On behalf of the Directors of Mountainview Niagara Escarpment Community Association (MNECA) please find attached our comments and objects regarding the Niagara Escarpment Crossing Study Terms of Reference for an IEA

RE: Notice of Commencement of the Terms of Reference for the Niagara Escarpment Crossing Individual Environmental Assessment, Town of Grimsby, Town of Lincoln, Township of West Lincoln

The following are our comments and objections to the Notice of Commencement of the Terms of Reference for IEA for the Niagara Escarpment Crossing Study

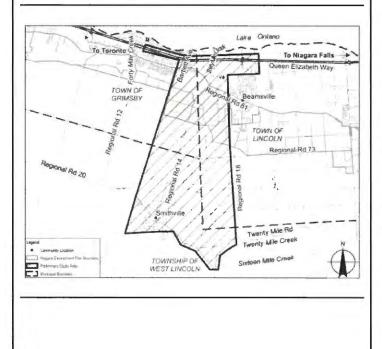
The study area, as indicated in the Region's Notice of Commencement of the Terms of Reference for an Individual Environmental Assessment of June 27, 2023, includes Mountainview Road and Thirty Road as north-south crossings which is contrary to what was authorized by Regional Council on May 19, 2016 of PWC 27-2016 and was based on the recommendations of the Niagara Escarpment Crossing Study by Hatch Mott MacDonald (Hatch Study) 2016. Council authorized the EA process for the "Bartlett Avenue Extension." Including Mountainview Road and Thirty Road as potential alternates is contrary Regional Council's authorization and contrary to the Region's Transportation Master Plan (2017); contrary to the Lincoln Transportation Master Plan (2019); contrary to the Niagara Official Plan (2022); and contrary to what the citizens of Mountainview Road and Thirty Road have been told and led to believe by the actions and proceedings of the Region and Town in relation to the above studies and Plans.

"The preliminary study area for the proposed north-south transportation crossing includes portions of the Town of Grimsby, Town of Lincoln, and Township of West Lincoln in Niagara Region, as shown in the key plan below."
